**Coal Combustion Waste Impoundment
Dam Assessment Report**

***Fly Ash Pond & Bottom Ash Pond
American Electric Power
Philip Sporn Generating Plant
New Haven, West Virginia***

**Assessment of Dam Safety
Coal Combustion Surface Impoundments
For the REAC Program**

**October 2009
Revised December 9, 2009**

Figure 2.4.1 j: Fly Ash Pond Eastern Dike

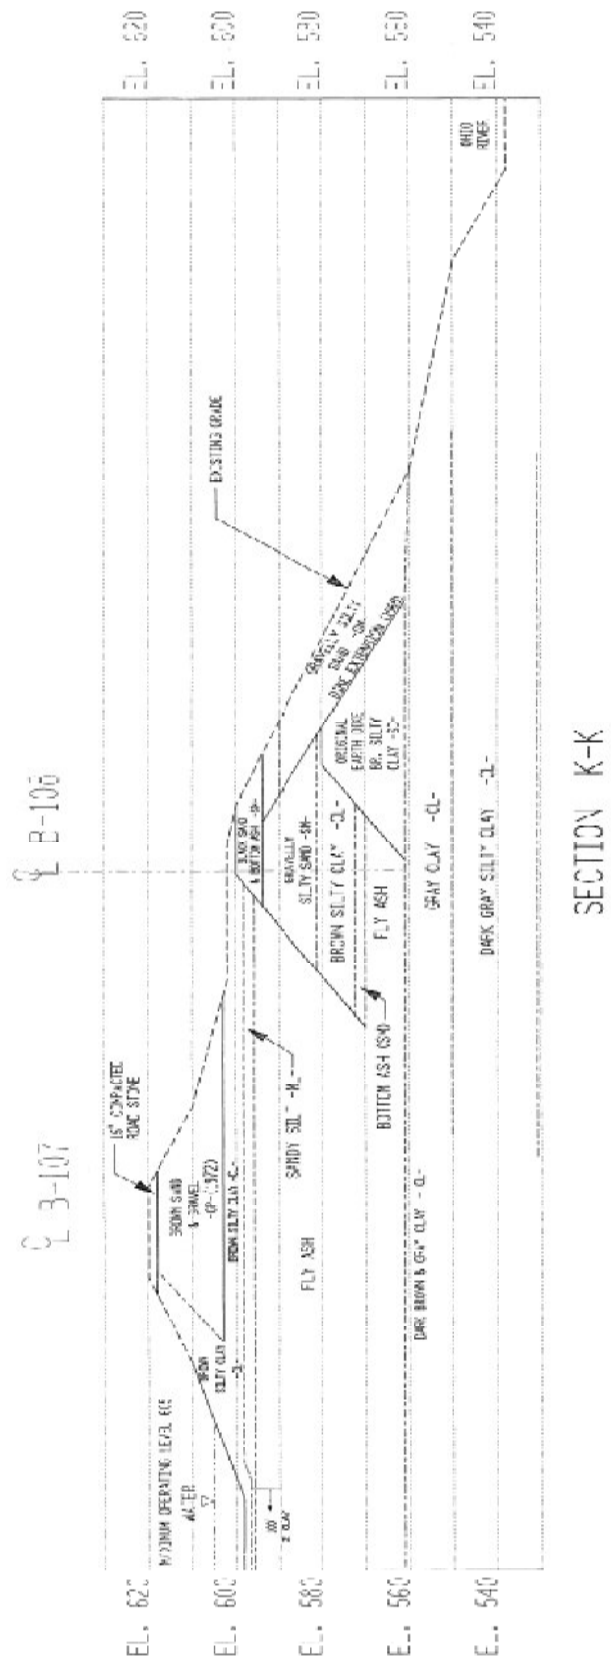
The eastern dike section makes use of a blanket drain as well as the granular soils contained within the embankment shell to provide seepage control. The dike is constructed over strata of clay, sand and gravel, and sandstone. The embankment dike contains portions placed over a 32.5 to 37.5 foot stratum of fly ash, 5 to 7 feet of bottom ash, and 2 feet of bottom ash on top of 9 feet of fly ash (resulting from various embankment modifications). Figures 2.4.l j, k, l, and m reflect the subsurface conditions along the eastern dike. See Appendix A (Doc 19: Philip Sporn Plant Drawings 2.pdf) for full size drawings of these subsurface conditions.

Fly Ash Pond - Original foundation soil conditions do not appear susceptible to support liquefaction. However, modifications to the pond include sections of embankments constructed over and/or composed of strata of fly ash material, which may be susceptible to liquefaction under proper conditions.

Figure 4.1.2 a: Fly Ash Pond Impoundment History (North to South Profile)

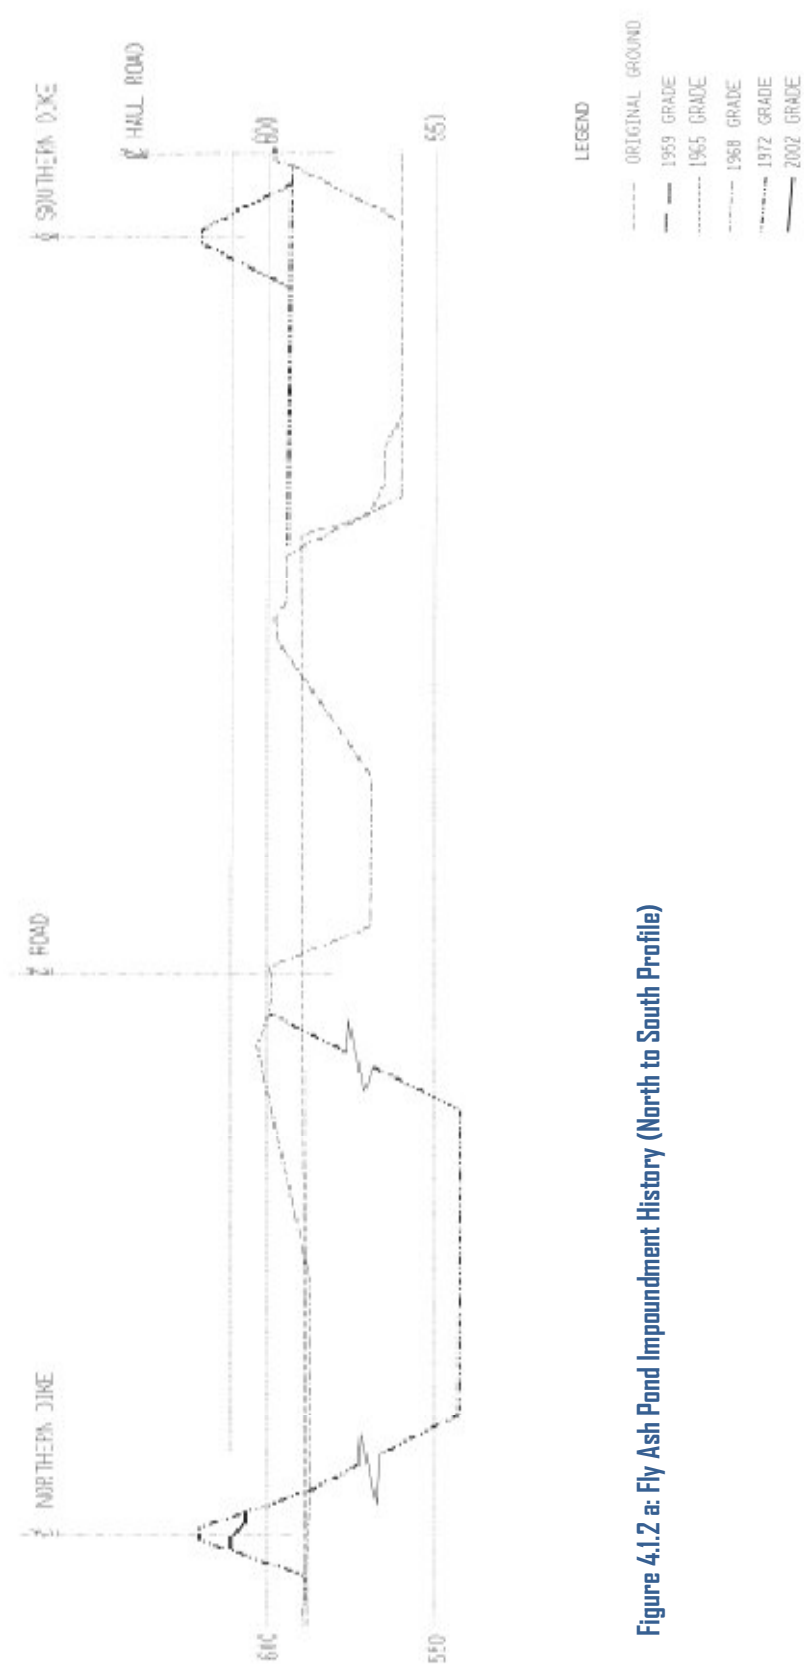
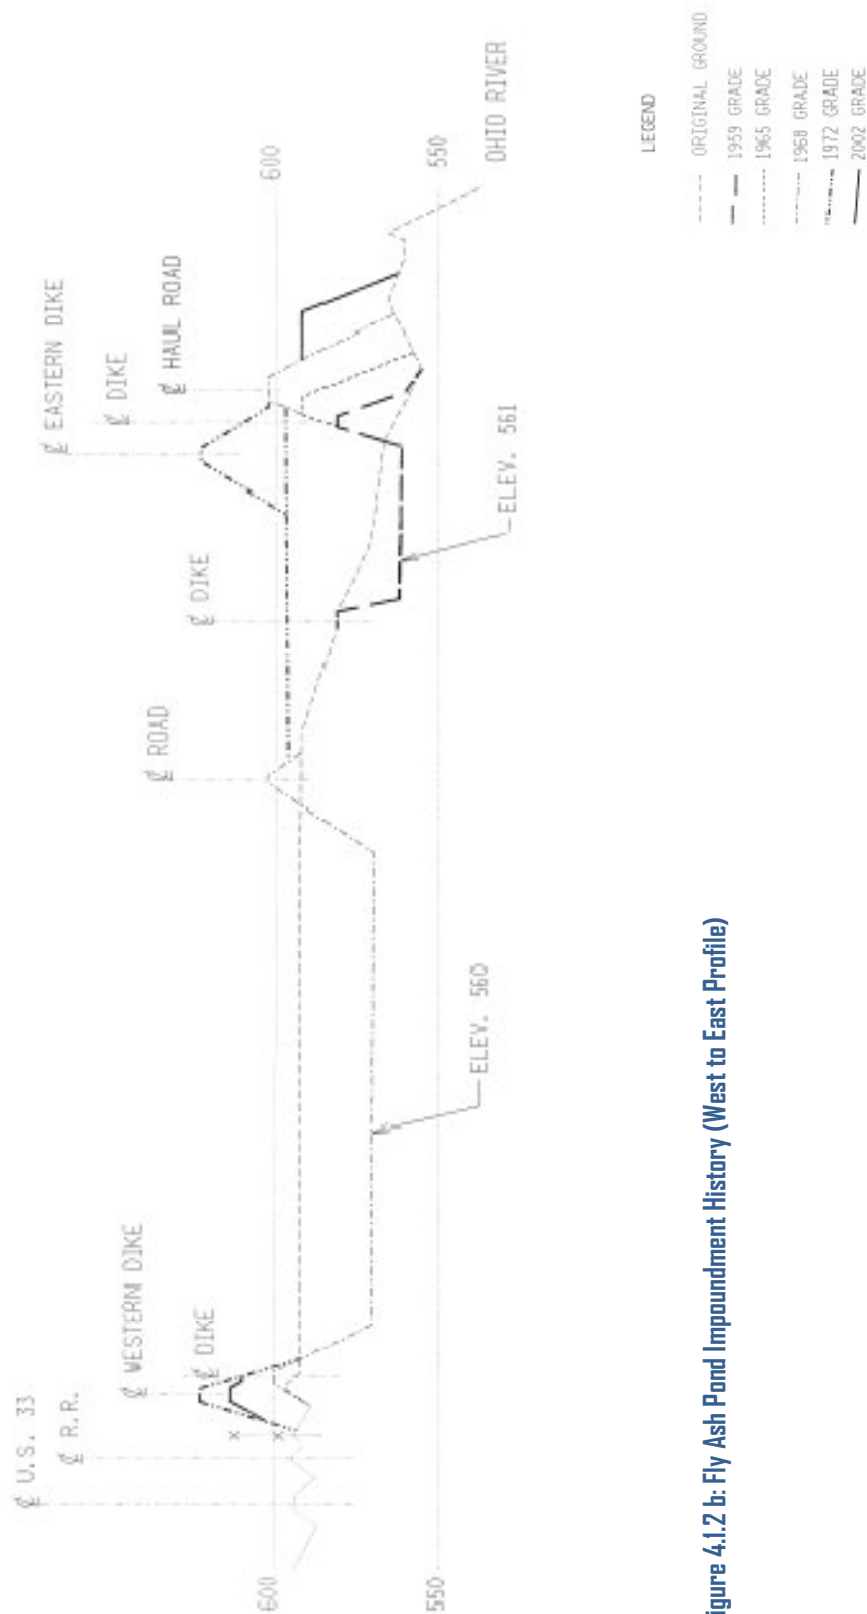
The last modification to the northern dike was performed in 2002. The dike was lowered approximately 5 feet, to an elevation of 613. Therefore, the existing condition of the northern dike consists of a maximum total height of 30 to 35 feet, with a downstream slope of approximately 2.5 horizontal to 1 vertical and an upstream slope flatter than 2 horizontal to 1 vertical.

The last modification to the western dike was performed in 2002. The dike was lowered approximately 6 to 8 feet, to an elevation of 610 to 611.5. Therefore, the existing condition of the northern dike consists of a maximum total height of 22 to 27 feet, with a downstream slope of approximately 3 horizontal to 1 vertical and an upstream slope of 3 horizontal to 1 vertical or flatter.

The last modification to the southern dike was performed in 2002. It is believed that a portion of the dike was lowered approximately 5 feet, to an elevation of 612, while a portion of the dike was maintained.

The last modification to the eastern dike was performed in 2002. The dike crest elevation and road elevation were maintained and an additional berm was constructed along the downstream slope of the dike (towards the Ohio River). The downstream slope is as steep as approximately 2 horizontal to 1 vertical and the additional berm has a width of approximately 60 feet.
